## HISTORIC AND DESIGN REVIEW COMMISSION

**HDRC CASE NO:** 2020-335  
**ADDRESS:** 529 N PALMETTO  
**LEGAL DESCRIPTION:** NCB 1371 BLK 3 LOT 29 & 30  
**ZONING:** RM-4, H  
**CITY COUNCIL DIST.:** 2  
**DISTRICT:** Dignowity Hill Historic District  
**APPLICANT:** Abigail Arispe/GALLEGO LAZARO A & OZUNA LILLIAN  
**OWNER:** Abigail Arispe/GALLEGO LAZARO A & OZUNA LILLIAN  
**TYPE OF WORK:** Removal of brick chimney  
**APPLICATION RECEIVED:** July 20, 2020  
**60-DAY REVIEW:** Not applicable due to City Council Emergency Orders  
**CASE MANAGER:** Huy Pham

The applicant is requesting a Certificate of Appropriateness for approval to remove the existing brick chimney.

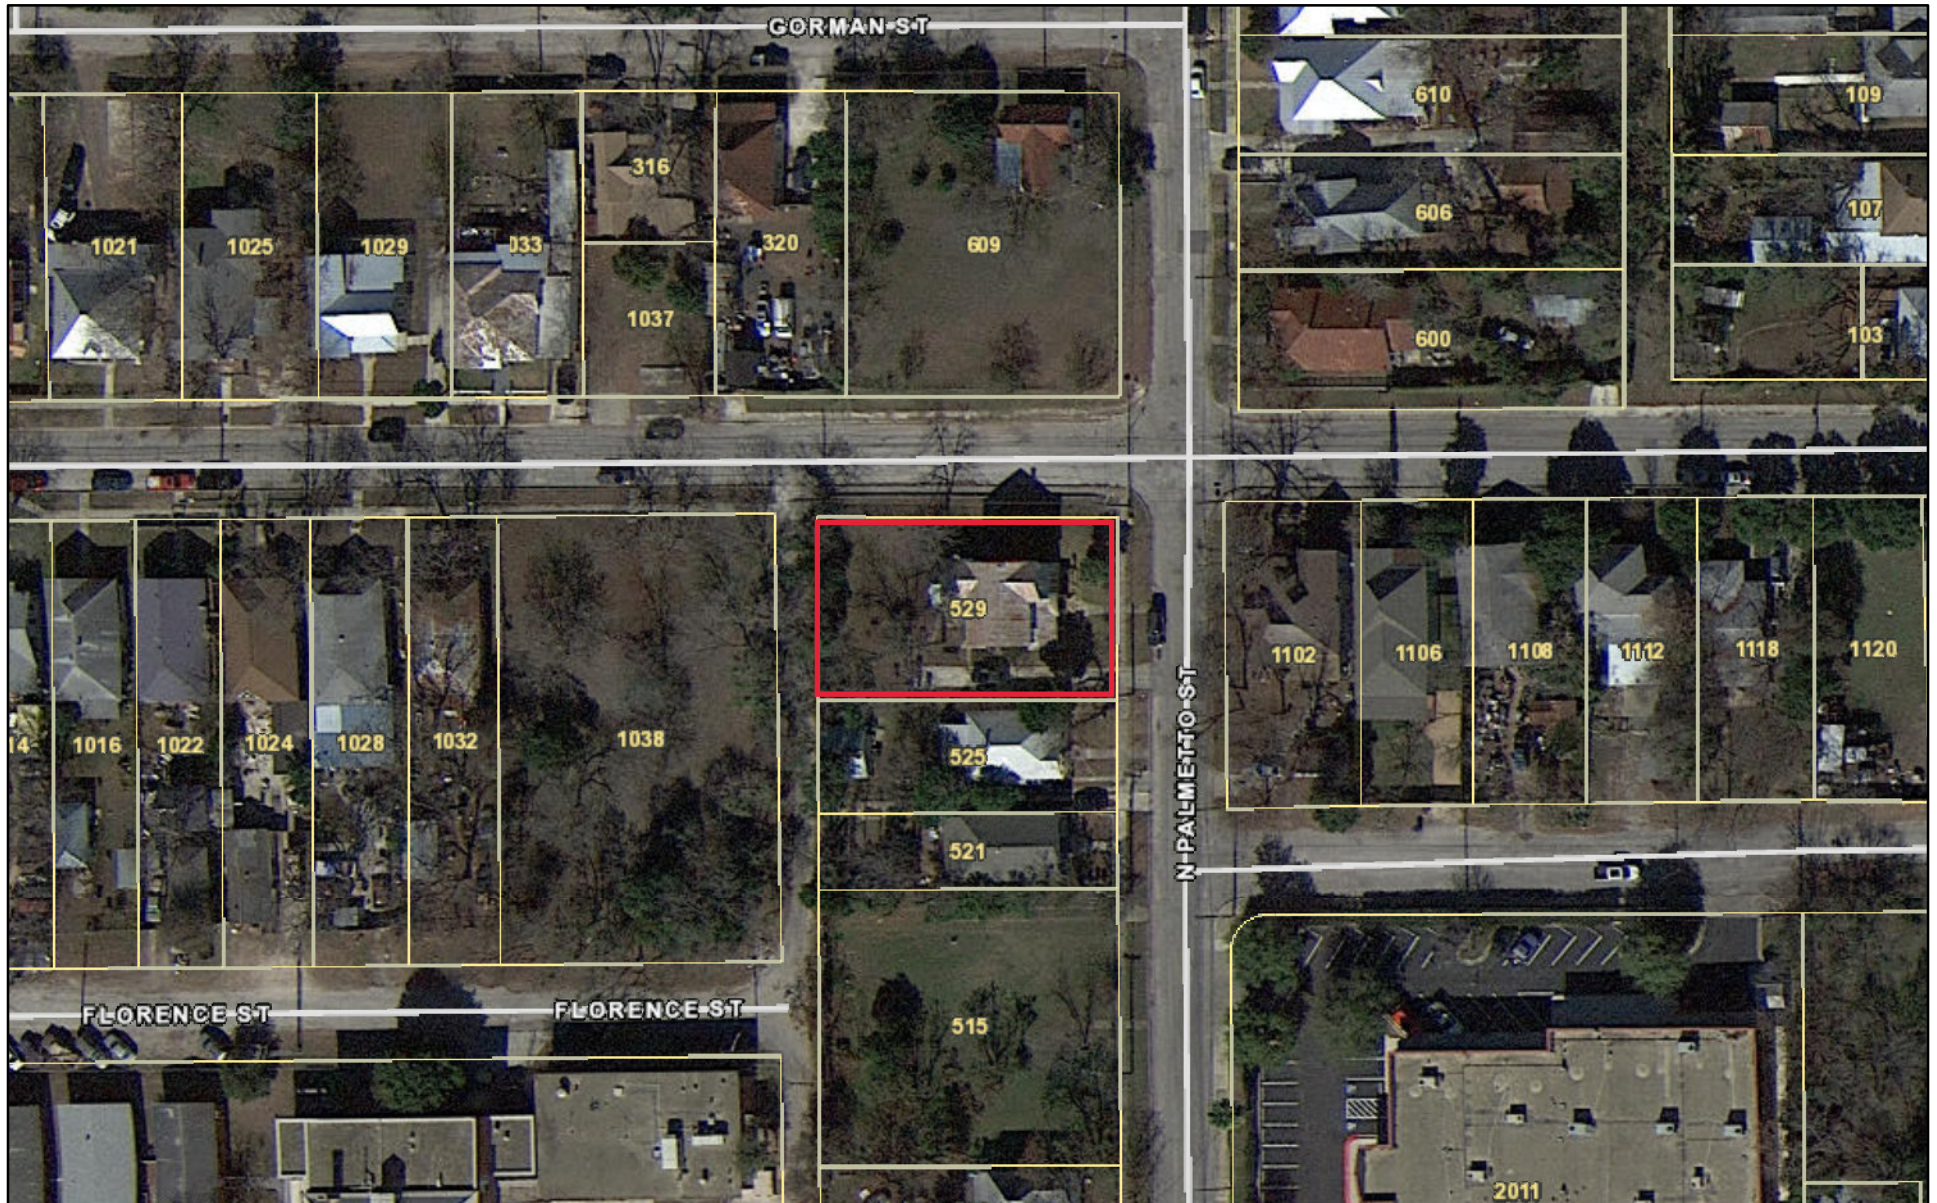
- b. CHIMNEY – The applicant has proposed to remove the brick chimney located on the north façade facing Dawson. The chimney features fully exposed brick construction with a tapered crown, stepped shoulders on the exterior of the mantle, and white paint finish. The chimney has begun buckling most at the mantle. Staff finds that the chimney is a character-defining feature of the structure and while it may be temporary deconstructed during structural repairs of the primary structure, it should be reconstructed based photo-documentation and a measured drawing submitted to staff.

Staff does not recommend chimney removal based on finding b. If temporary removal is required for structural repairs on the primary structure, staff recommends the chimney is reconstructed in-kind with the following stipulations:

1. That the chimney is deconstructed to salvage and reuse as many original bricks as possible
2. That no work is performed prior to submitting thorough photo-documentation and a measured drawing of the chimney.
